Re: Public Notice AL04-02209-L

This comes in response to the above referenced Public Notice for the expansion of the Tallassee Waste Disposal Center (TWCD) located in Tallassee, Alabama, Tallapoosa County.

PUBLIC NOTICE NO. AL04-02209-L

**WETLAND FILL FOR TRUCK YARD, POND AND BORROW AREA
UNNAMED TRIBUTARY TO GLEEDEN BRANCH, TALLAPOOSA COUNTY, ALABAMA**

DEVELOPMENT PLAN

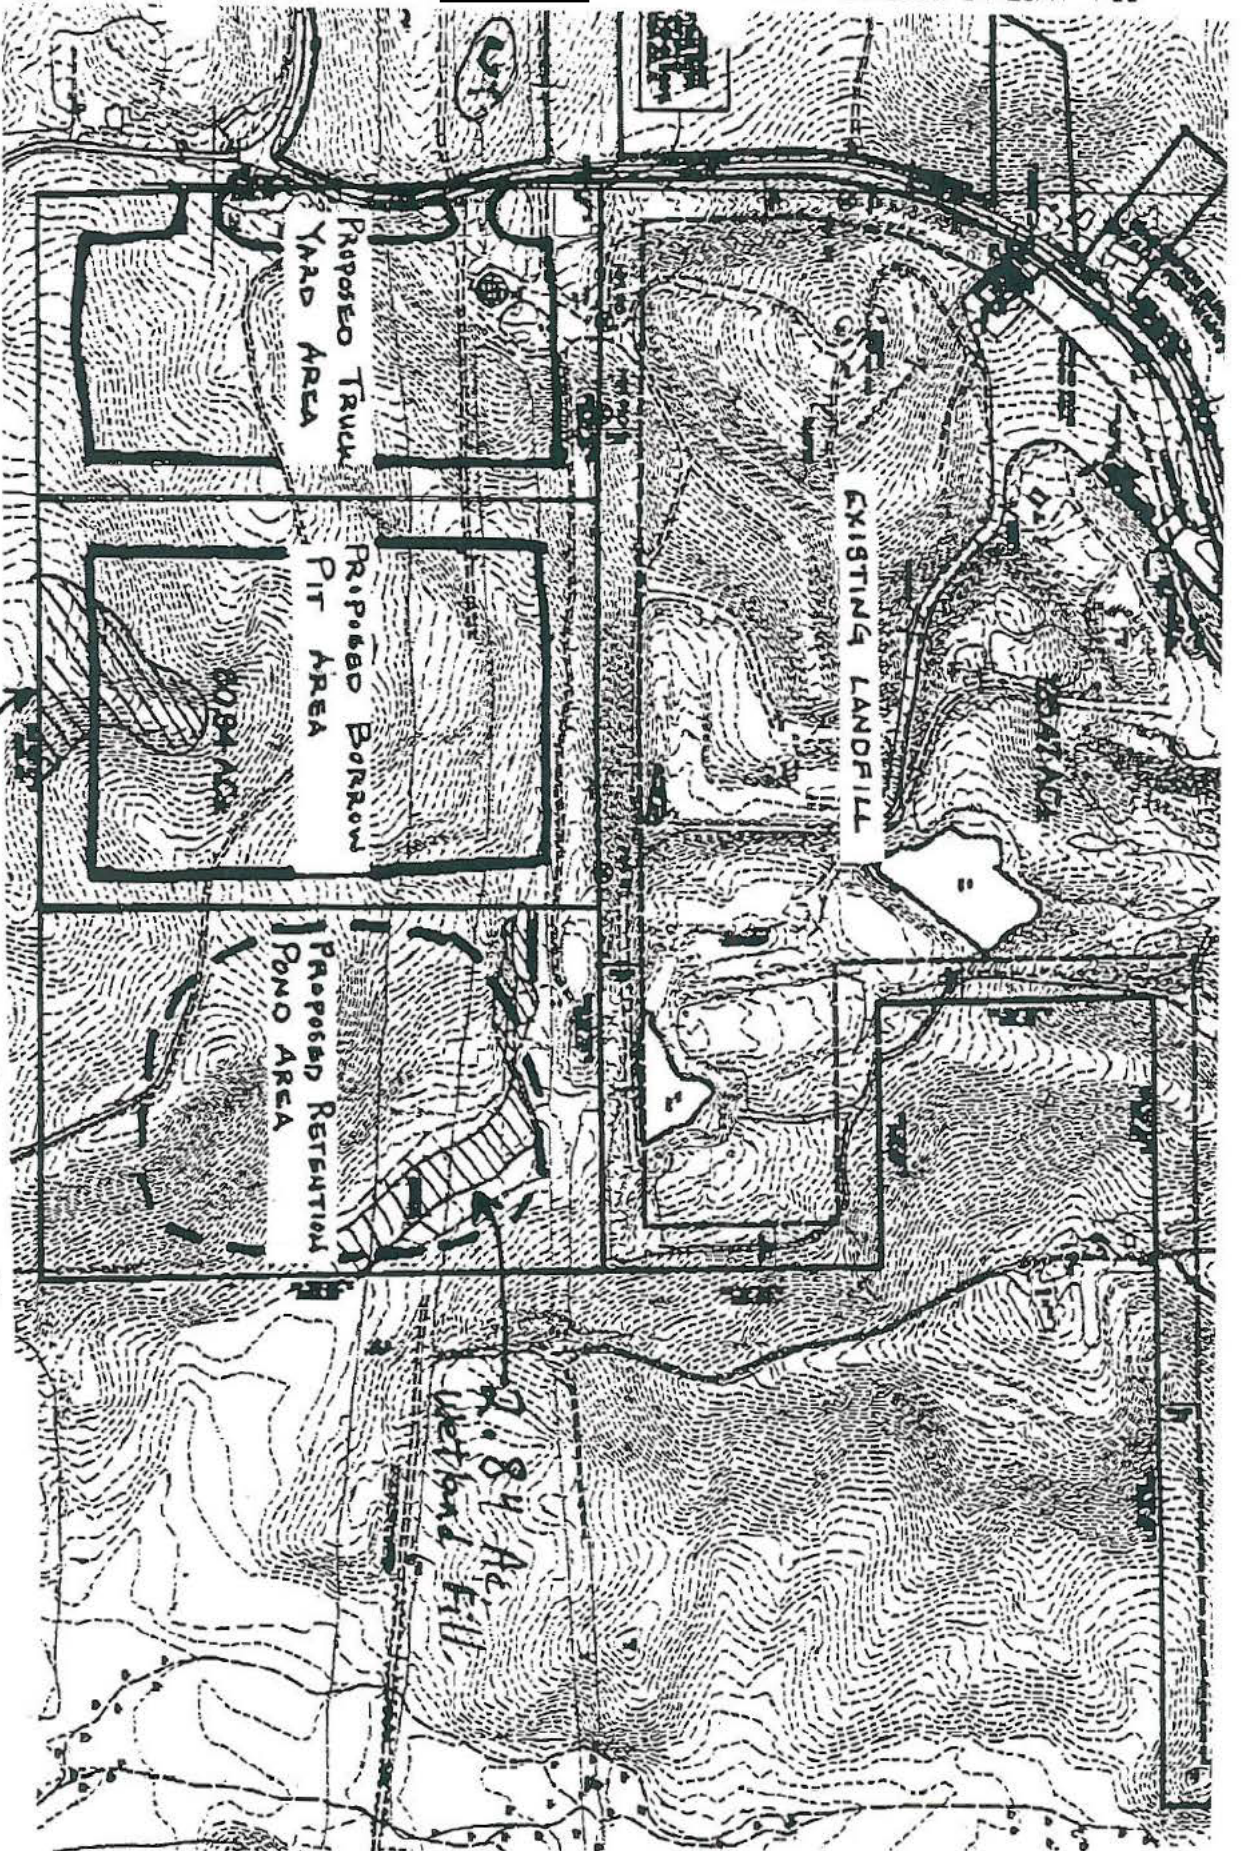
The establishment of a borrow pit and a proposed retention pond is too generic and should be further explained as to use and impact on the most populated part of the community. A borrow pit and holding pond are breeding grounds for insects and disease.

This notice fails to address access roads, the specific function of the truck yard and the incorporation of the new area into the existing facility. The locating of garbage trucks with remnants of waste within a block of our local church and citizens is a health concern, specifically air quality, insects and rodents.

This expansion moves a truck yard in the vicinity of the most populated area of the community. The location is at an intersection and at the foot of a small hill. Traffic traveling south will approach the area from a blind spot. This creates a potential for an increase in traffic accidents.
